NL-08-1228

**Vogtle Electric Generating Plant**  
**Supplemental Response to NRC Generic Letter 2004-02**

### Vogtle Electric Generating Plant Supplemental Response to NRC GL 2004-02

Figure 1 – Pressure Loss as a Function of Time

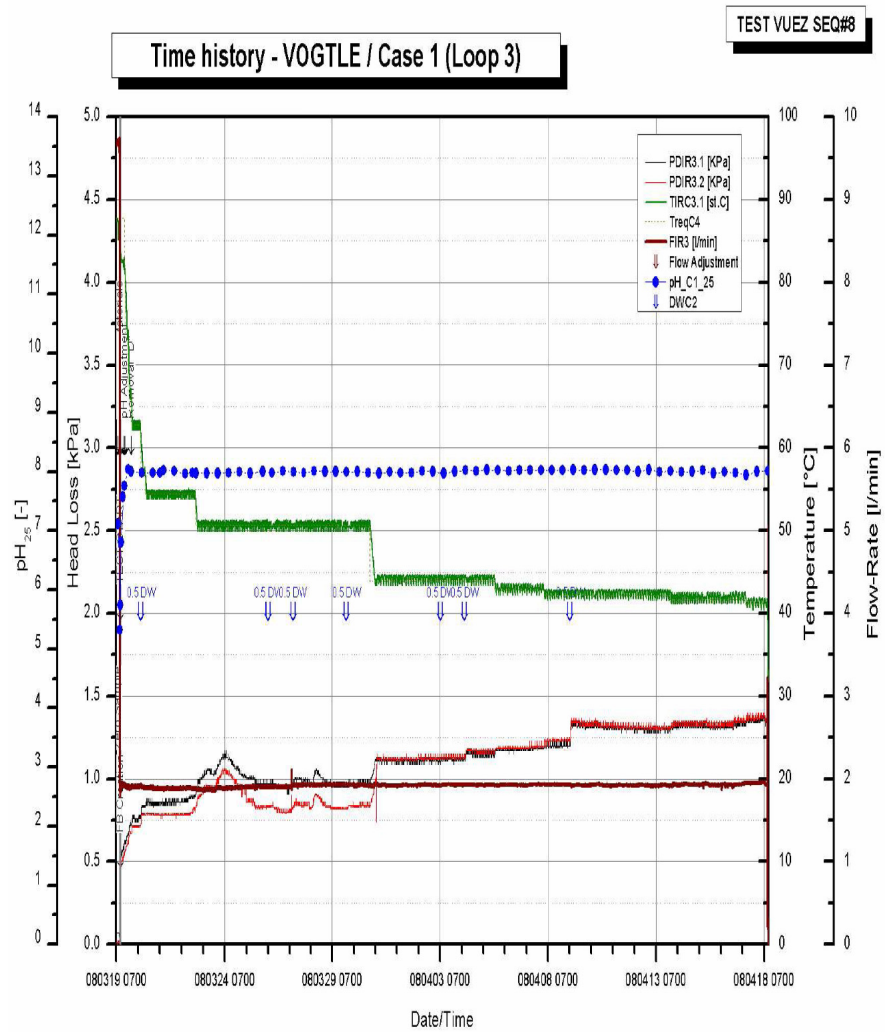
- 27) 17.d.i Data Analysis: Licensees should provide a copy of the pressure drop curve(s) as a function of time for the testing of record.**

The following Figure 1 is the pressure loss curve as a function of time for the Vogtle VUEZ 30 day experiment.

Figure 2 – Test Start Data

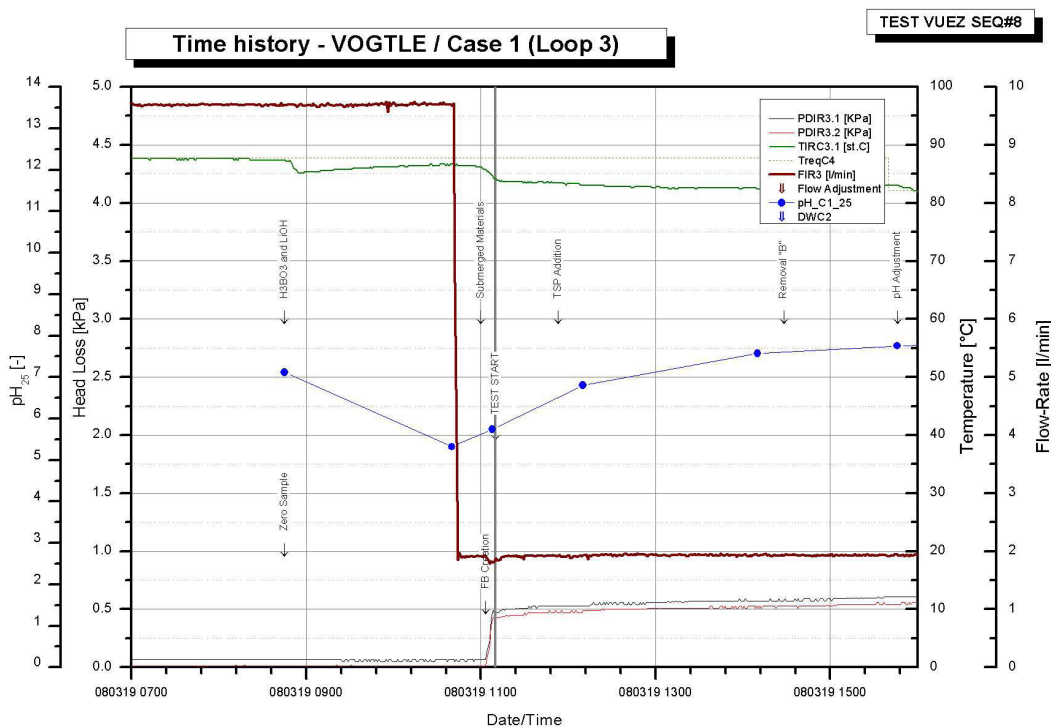
**34) 22.d.i Data Analysis Bump Up Factor:** Licensees should provide the details and the technical basis that show why the bump-up factor from the particular debris bed in the test is appropriate for application to other debris beds.

Vogtle evaluated the impact of chemical effects on the limiting debris bed. The non-chemical head loss testing at CDI confirmed that the maximum debris head loss provided higher head losses over the thin bed debris load. The chemical effects testing performed by Alion evaluated the maximum debris bed to ensure the maximum impact of chemical effects was realized. The increase in head loss due to chemical effects for this test was for the most part negligible as expected. Figure 2 illustrates the beginning of the experiment. The reference or non-chemical head loss is at 12:10:24 on 3/19/2008, right after the acid addition and TEST START.
